QUINEBAUG VALLEY MIDDLE COLLEGE HIGH SCHOOL
742 UPPER MAPLE STREET
DANIELSON, CONNECTICUT
DCS PROJECT: BI-CTC-439
SDE PROJECT NO 584-0001N

BID OPENING	1:00 P.M.	November 22, 2011
ADDENDUM NUMBER #1	DATE OF ADDENDUM	November 10, 2011

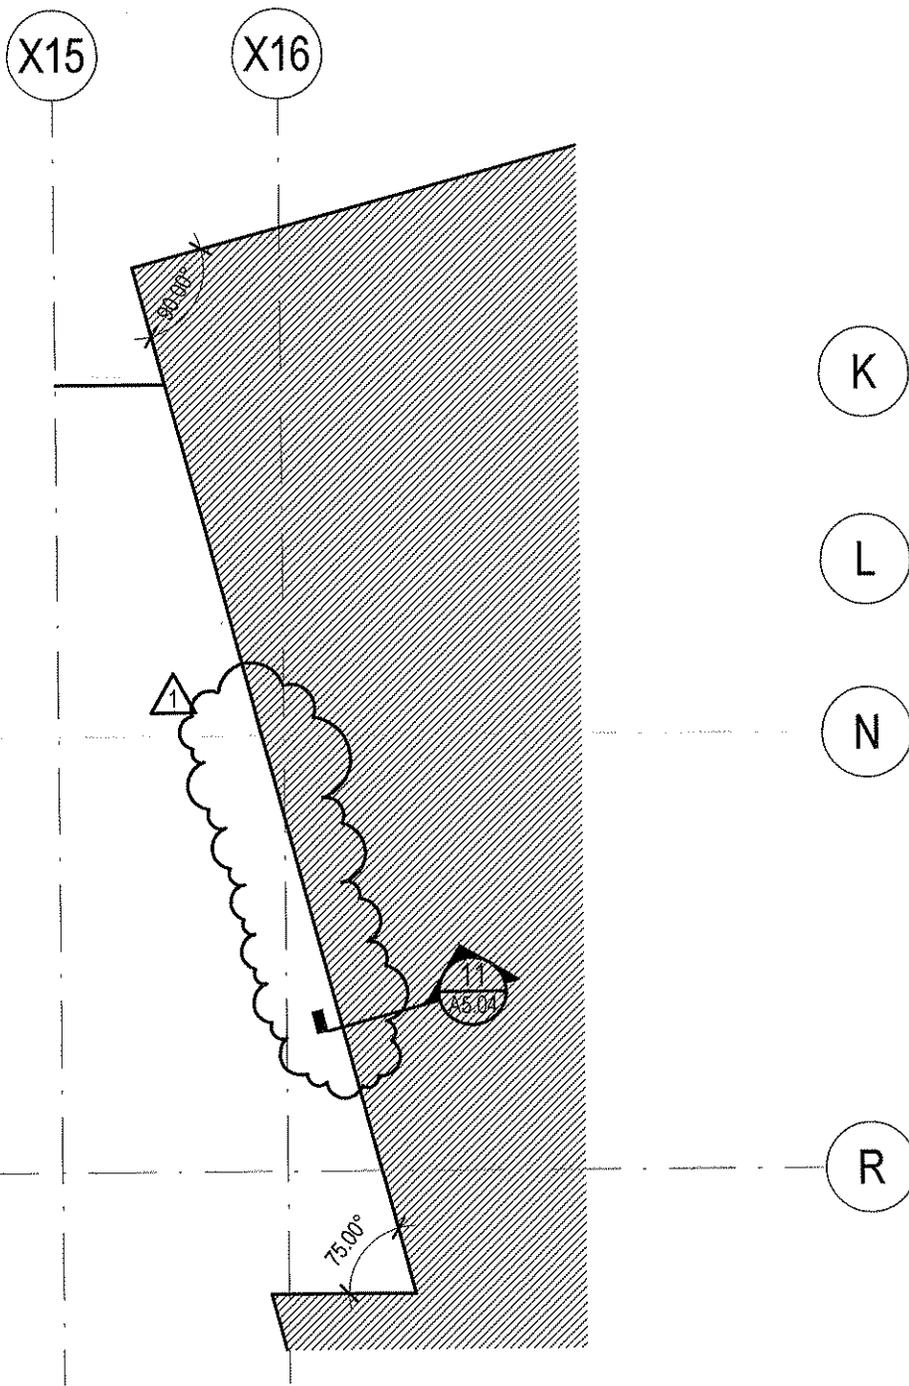
Sheet A1.13 – REVISE detail 8 as shown on attached sketch ADD1-A13.
- Item 56
Sheet A1.17 - REVISE detail 1 as shown on attached sketch ADD1-A1.
- Item 57

6 CORRIDOR 2006 WEST

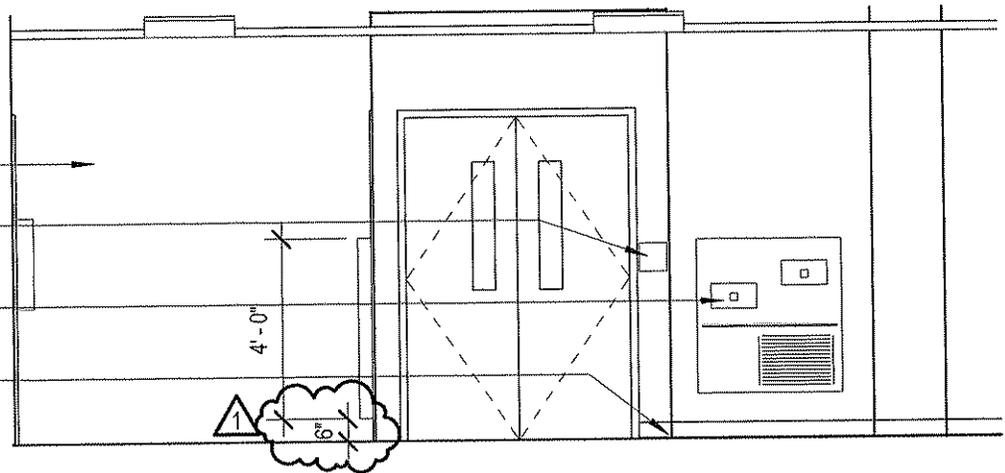
- Item 68
Sheet A8.02 – REVISE detail 11 as shown on attached sketch ADD1-A6.
 - Item 69
Sheet A8.02 – REVISE detail 15 as shown on attached sketch ADD1-A4.

18 TOILET RM #2023 - WEST

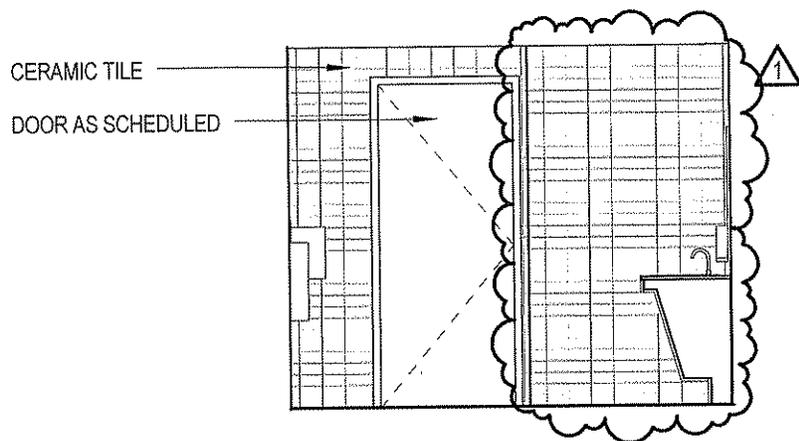
- Item 70
Sheet A8.02 – REVISE detail 18 as shown on attached sketch ADD1-A7.

2 INT ELEV @ ADMIN WK RM SOUTH

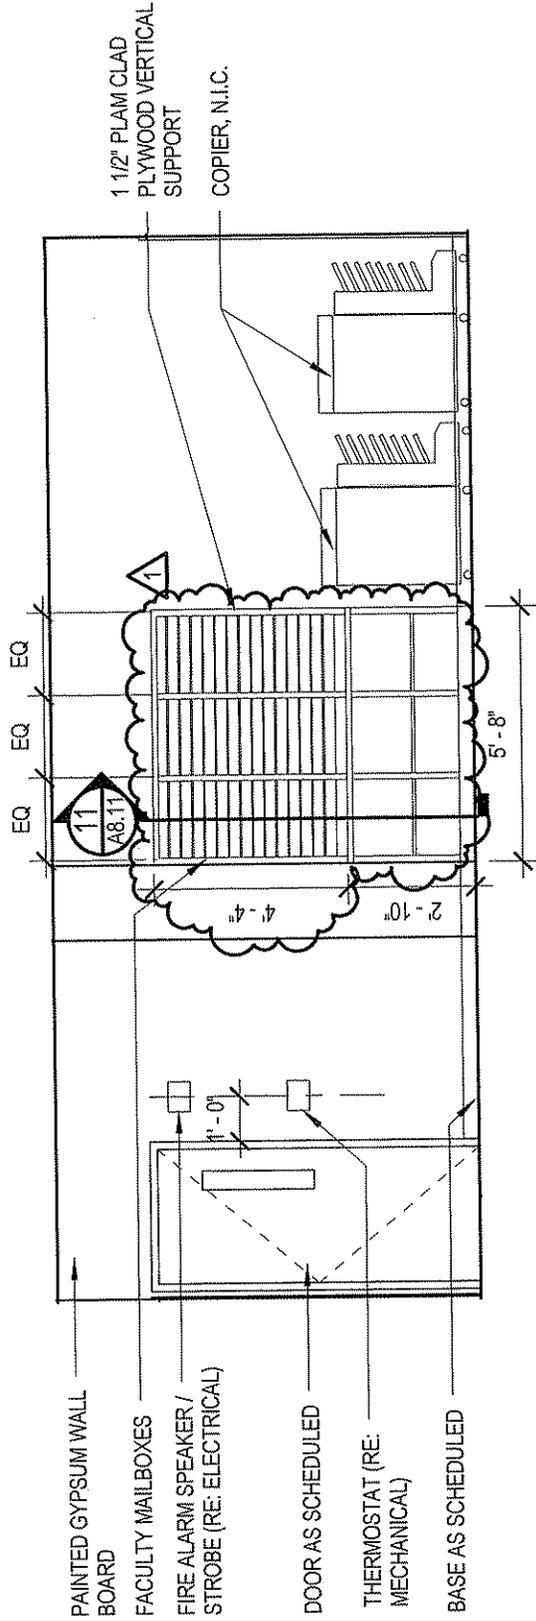
- Item 63
Sheet A8.01 – detail 19, DELETE note "12" wide x 60" high x 18" deep double tier locker with sloped top, typ"
 - Item 64
Sheet A8.02 – REVISE detail 2 as shown on attached sketch ADD1-A9.

4 INT ELEV @ ADMIN WORK ROOM WEST

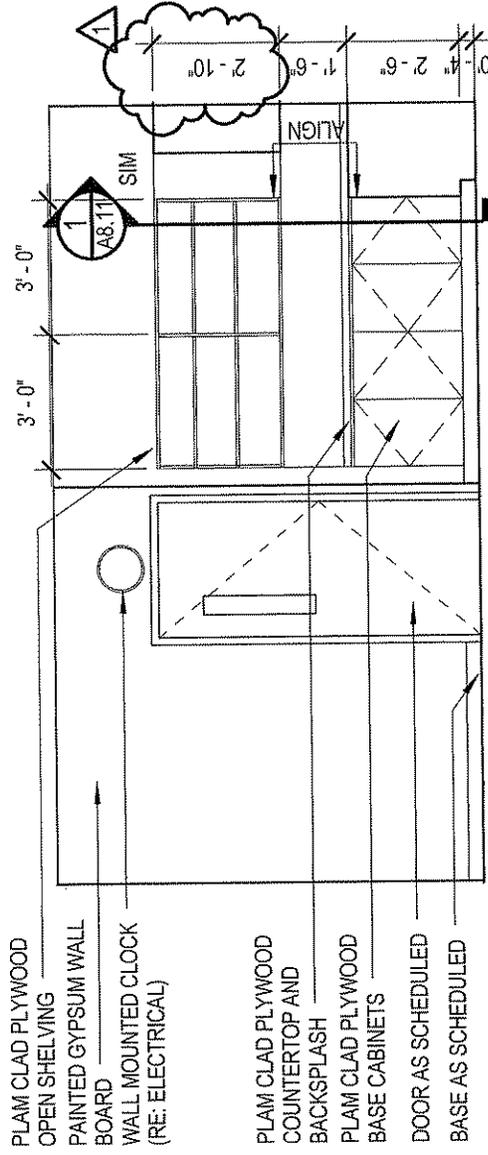
- Item 65
Sheet A8.02 – REVISE detail 3 as shown on attached sketch ADD1-A11.
 - Item 66
Sheet A8.02 – REVISE detail 4 as shown on attached sketch ADD1-A10.

7 SECTION THROUGH RTU & ROOF DRAIN
 SCALE: 3/4" = 1'-0"

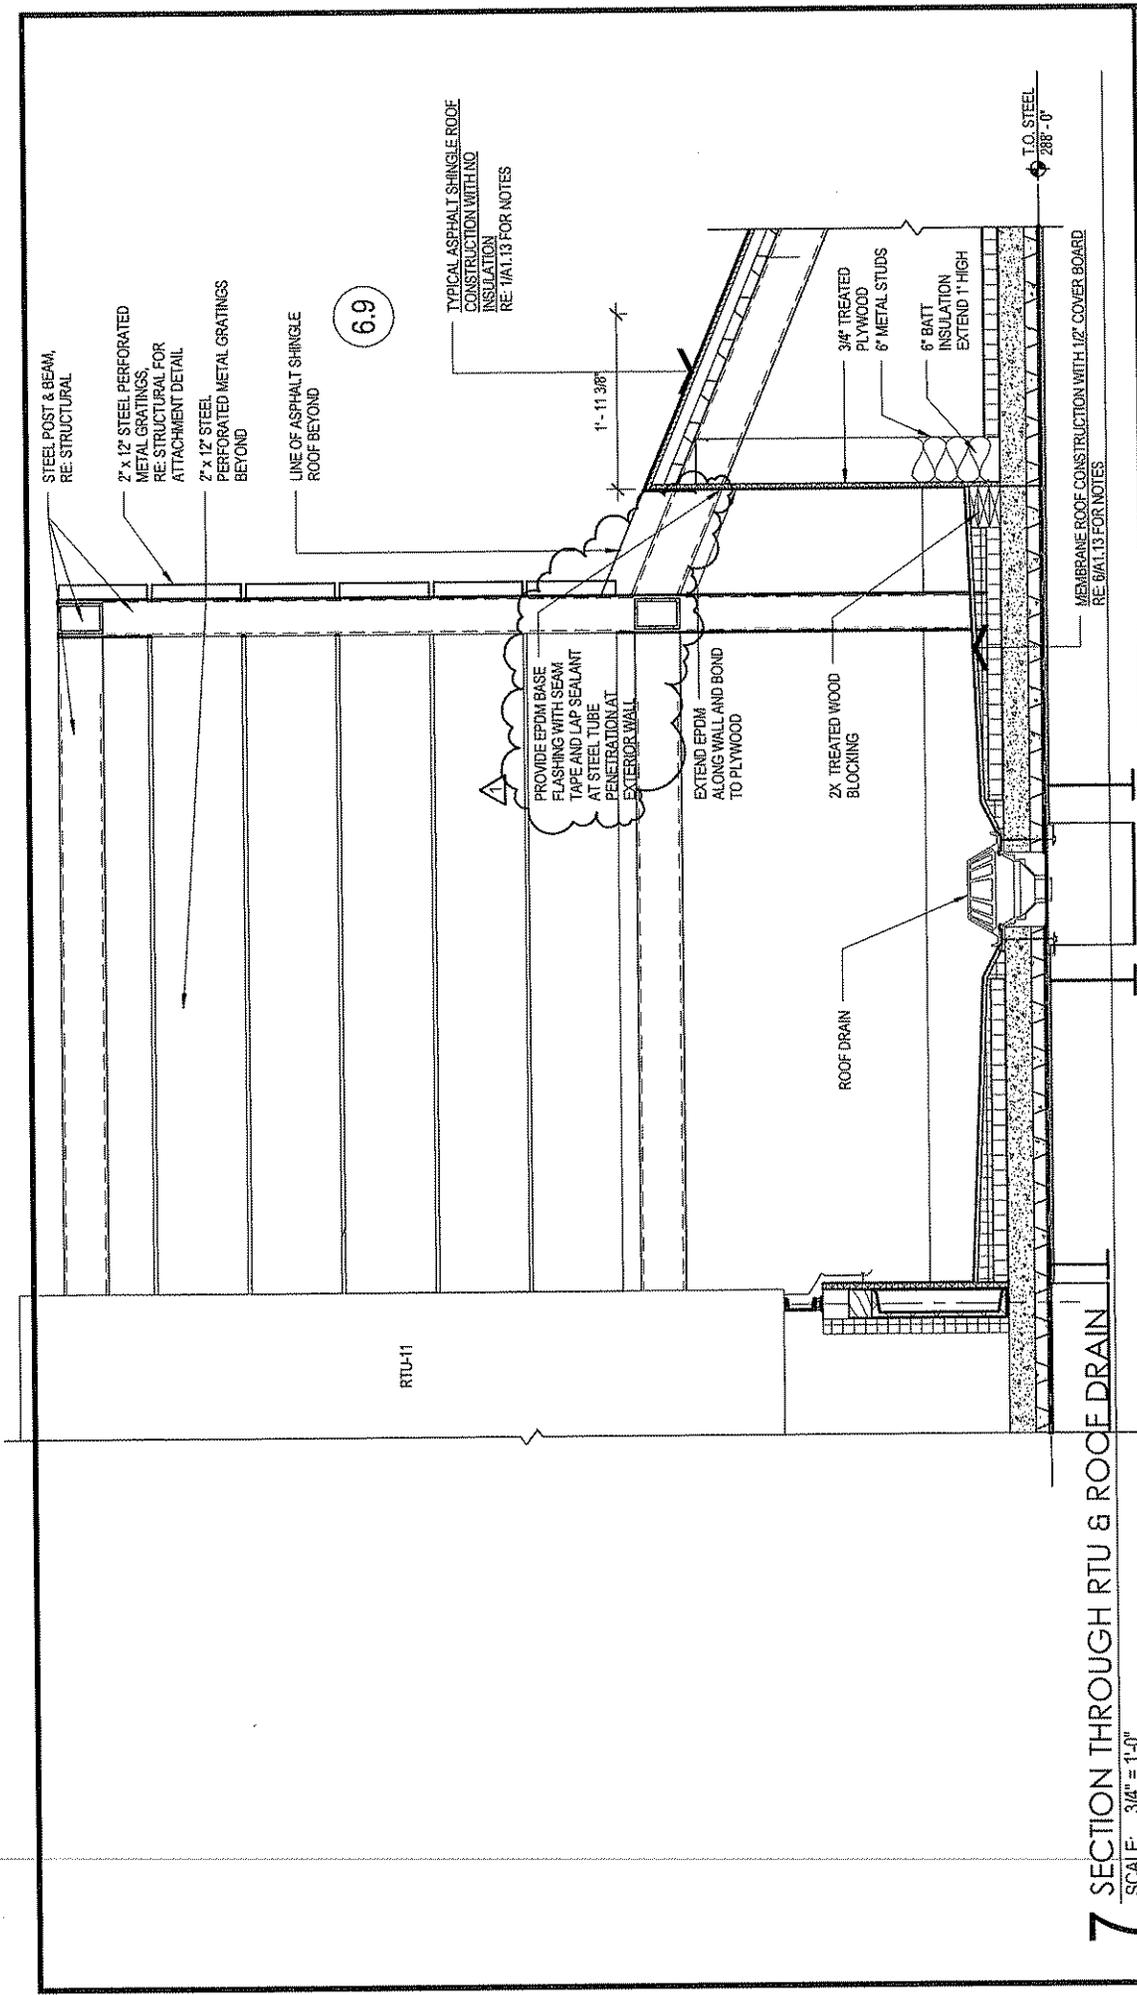
- 3/4" FIRE TREATED PLYWOOD
 - 3" POLYSTYRENE RIGID INSULATION
 - 8" CMU
- Item 54
Sheet A1.13 – REVISE detail 7 as shown on attached sketch ADD1-A12.
- Item 55

2 VCT SOFT JOINT DETAIL

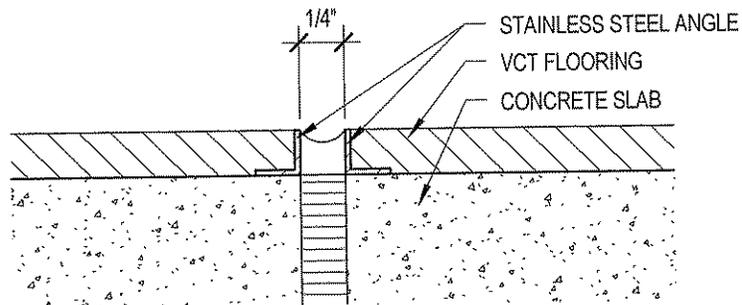
- Item 78
Sheet A9.01 – ADD detail 2 as shown on sketch attached ADD1-A15.
- Item 79
Sheet A9.03 – REVISE detail 1 by rotating the carpet tile pattern 90 degrees in the following rooms: Corridor 2 0001, Classroom 0002, Classroom 0003, and Computer Classroom 0004.

1 MAIN LEVEL DEMOLITION PLAN - EAST END OF COLLEGE (WITH TEMPORARY STAIR AND CORRIDOR)

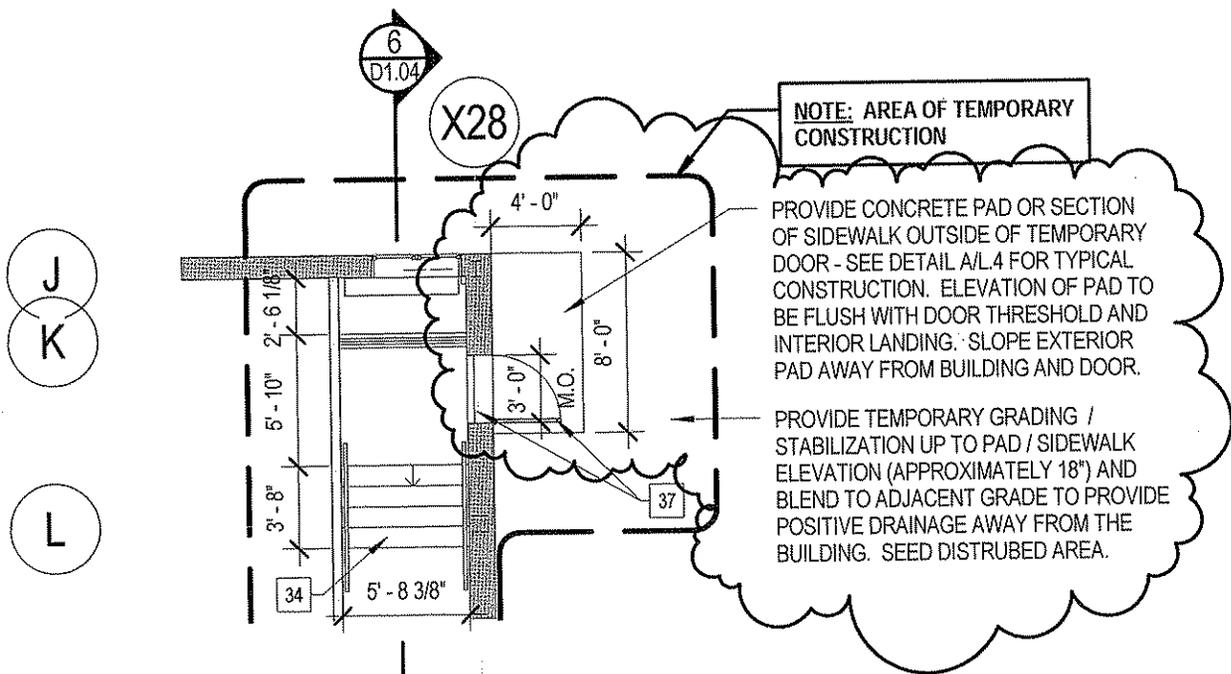
- Item 47
Sheet D1.02 – REVISE detail 1 as shown on attached sketch ADD1-A16.
- Item 48
Sheet D1.02 – REVISE detail 3 as shown on attached sketch ADD1-A17.

1 MAIN LEVEL REFLECTED CEILING PLAN

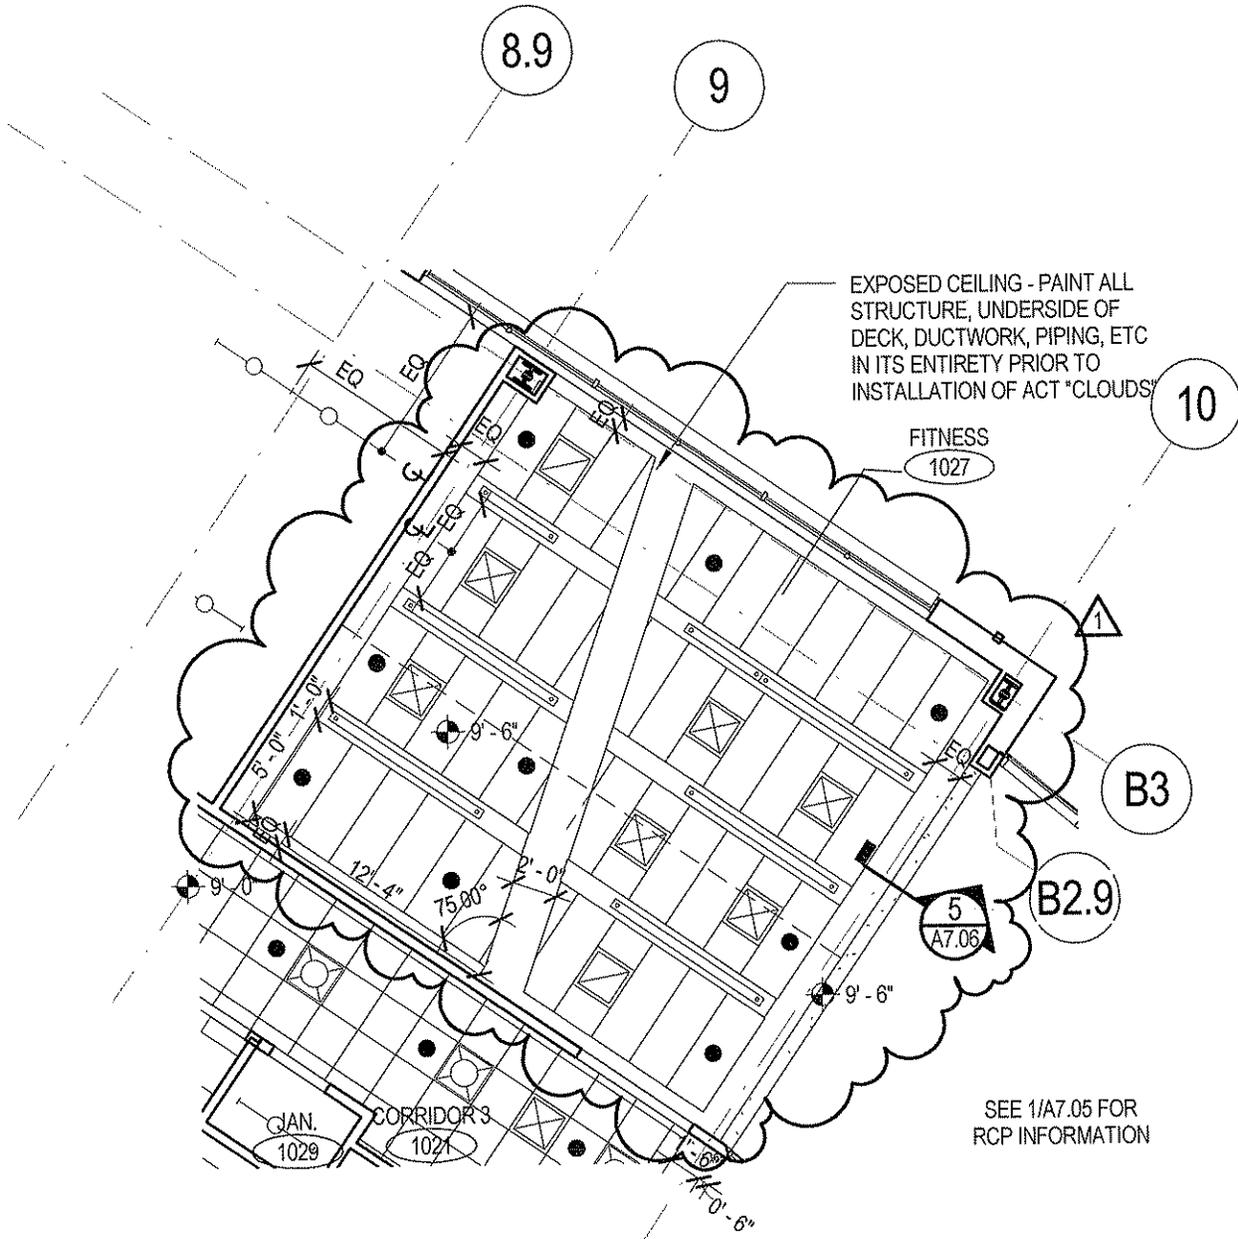
- Item 61
Sheet A7.05 – REVISE detail 1 as shown on attached sketch ADD1-A19.
 - Item 62
Sheet A7.06 – ADD detail 5 as shown on attached sketch ADD1-A20.

BVH PROJECT NO.	ISSUED BY	REVISION TO																
21-10-062	KFF	S1.01																
SCALE	DRAWN	DATE																
1/8" = 1'-0"	JWM/JLF	11.10.2011

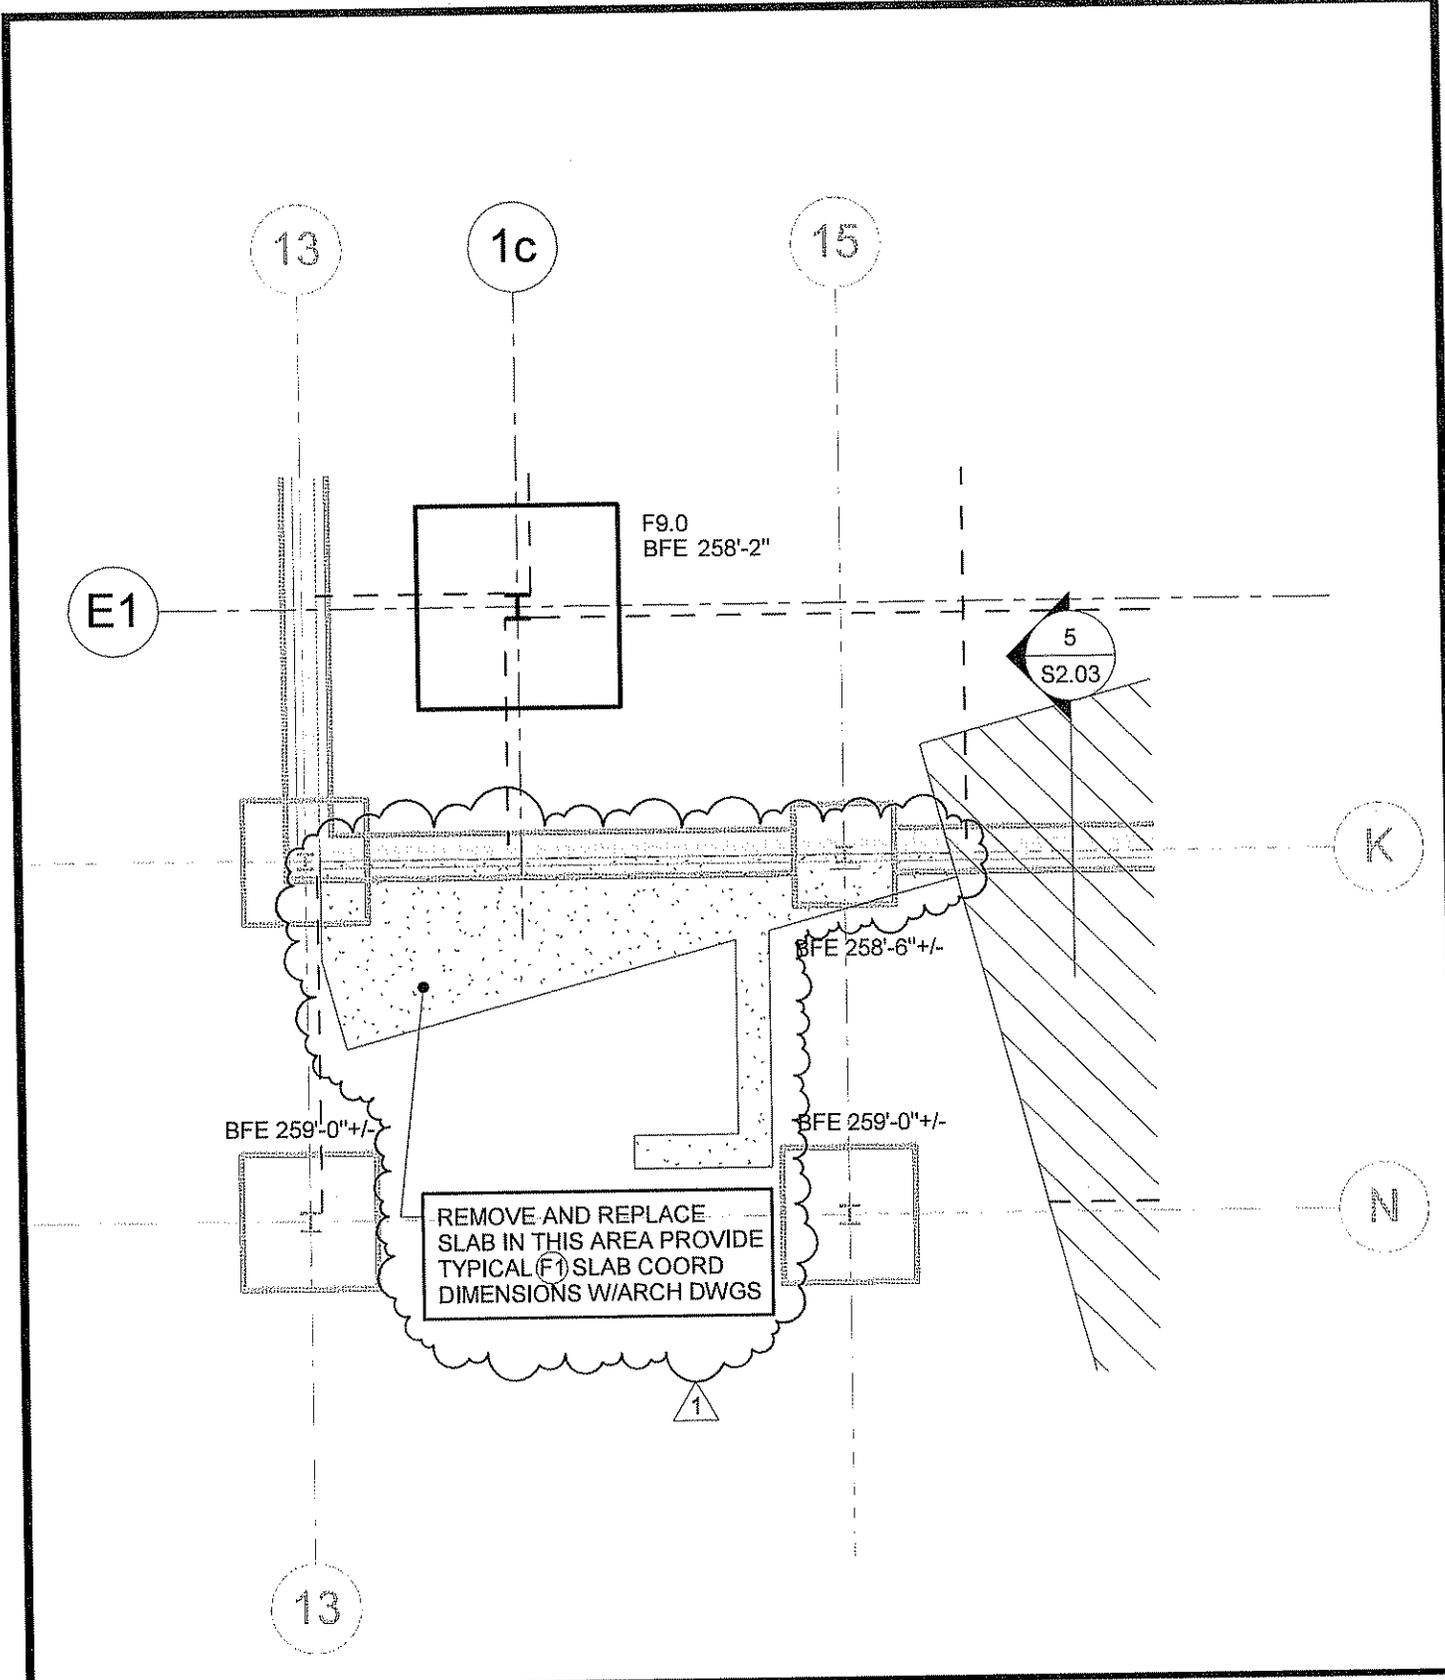
- Item 82
Sheet S1.01 – REVISE drawing as shown on attached sketch ADD1-S1.
- Item 83
Sheet S1.07 – DELETE HSS10x6x1/2 (LSV) spanning between columns B1-8 and B1-8.9.
